**RESOLUTION HOLDING HEARING ON APPEAL BY PENTA PARTNERS,
LLC OF THE CONDITIONS OF A SITE PLAN FOR PROPERTY LOCATED AT
2544 HUBBELL AVENUE**

Communication from the City Plan and Zoning Commission advising that at their April 5, 2018 meeting, the following action was taken regarding a request from Penta Partners, LLC (owner) represented by Travis Sisson (officer) for review and approval of a Site Plan "Classic Autoworx Site Improvements" under design guidelines for vehicle display lots on property located at 2544 Hubbell Avenue, to allow the property to be used for vehicle sales.

SITE PLAN FOR: CLASSIC AUTOWORX SITE IMPROVEMENTS

CLASSIC AUTOWORX SITE IMPROVEMENTS LANDSCAPE PLAN

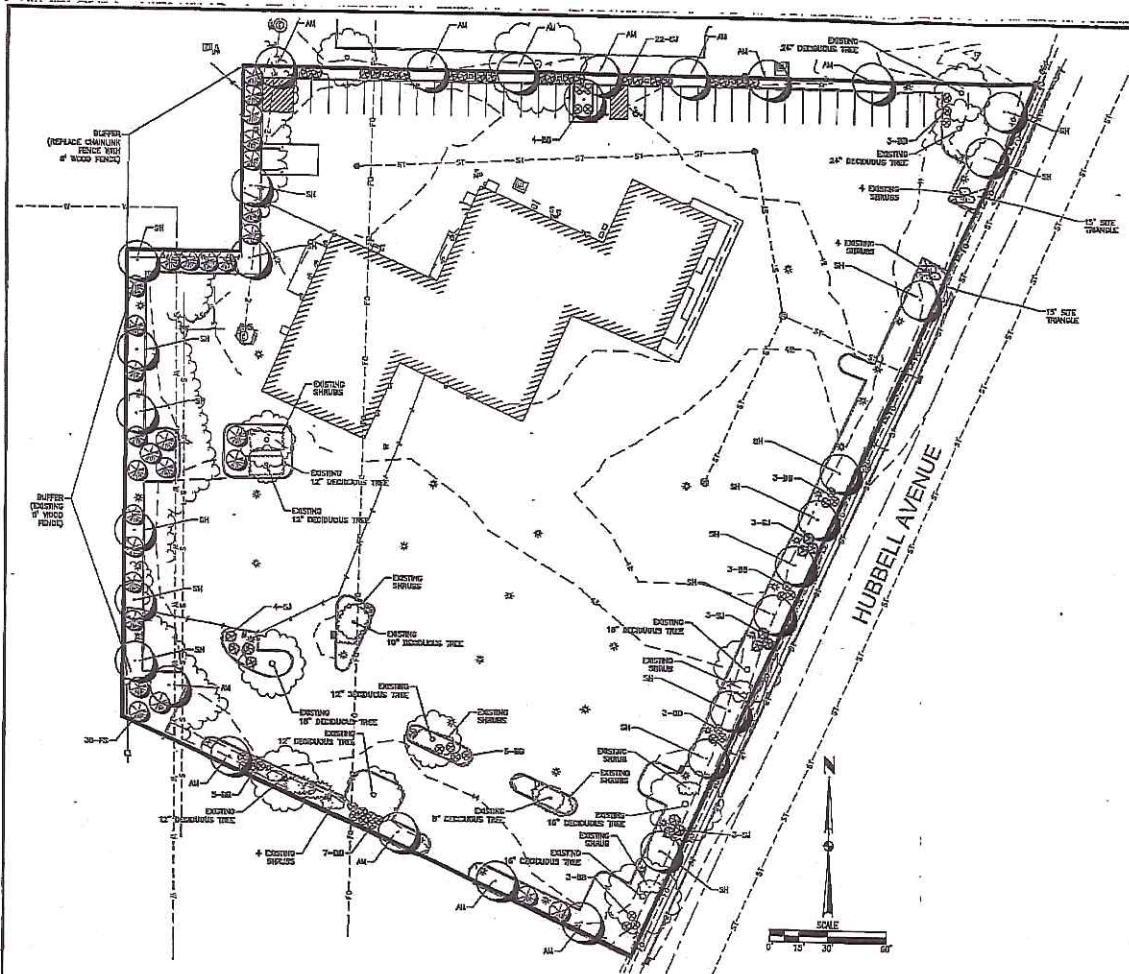
The proposed Site Plan does not provide the minimum required 20% open space requirement or provide the minimum 20 feet of paving setback required from an "R" Residential District. The Site Plan provides 15% open space and a 10-foot paving setback from the "R" District to west. Staff believes that removing pavement in order to provide a 20-foot paving setback is reasonably necessary to protect the adjoining school and residential uses. Furthermore, removing pavement would help the Site Plan achieve the minimum required 20% open space.

The proposed Site Plan does not comply with the City's Landscape Standards with regards to minimum required open space, minimum required buffer yard, minimum interior lot plantings, and screening. Staff believes that is necessary to comply with the Landscape Standards to protect the adjoining school and residential uses. The Site Plan should provide 20-foot paving setbacks along the western property line adjoining an "R" District and along the front property line along Hubbell Avenue. The Site Plan must also comply with the interior parking lot standards and provides the minimum required screening.

- 1. Landscaping and Buffering:** As noted above, the Site Plan does not comply with the City's Landscape Standards with regards to minimum required open space, minimum required buffer yard, minimum interior lot plantings, and screening. Staff believes that is necessary to comply with the Landscape Standards to protect the adjoining school and residential uses.
- 2. Traffic/Street System:** The proposed Site Plan does not alter the existing one (1) drive approach from Hubbell Avenue. However, it demonstrates retention of the two internal access drives to the property to the south. Staff recommends that these be removed and that curbing in these areas must be restored in order to prevent vehicles from encroaching into this area.

3. **Utilities:** There is an existing City of Des Moines-owned 10-inch sanitary sewer running north/south across this western portion of this parcel. A 30-foot wide sanitary sewer easement centered on this sewer should be provided. This existing sewer must be protected during any construction activities and maintenance access must be provided at all times.
4. **Additional Information:** The Site Plan demonstrates that refuse collection containers would be screened by an enclosure located near the northwest corner of the site.

1. Compliance with all administrative review requirements of the City's Permit and Development Center.
2. Provision of a 20-foot paving setback along the western property line adjoining an "R" District.
3. Provision of a 20-foot paving setback from the front property line along Hubbell Avenue.
4. Provision of interior parking landscaping that complies with the City's Landscape Standards.

5. Provision of a minimum required 6-foot tall opaque screen along all adjoining "R" Districts.
6. Provision of a note that states there shall be no elevated display of motor vehicles

9. The two internal access drives to the property to the south shall be removed and curbing in these areas shall be restored.
10. Provision of a 30-foot wide sanitary sewer easement centered on the north/south sewer within the western portion of the property.

11. Revise note on Site Plan to specify all pole mounted lighting shall have a maximum 20-foot pole height.
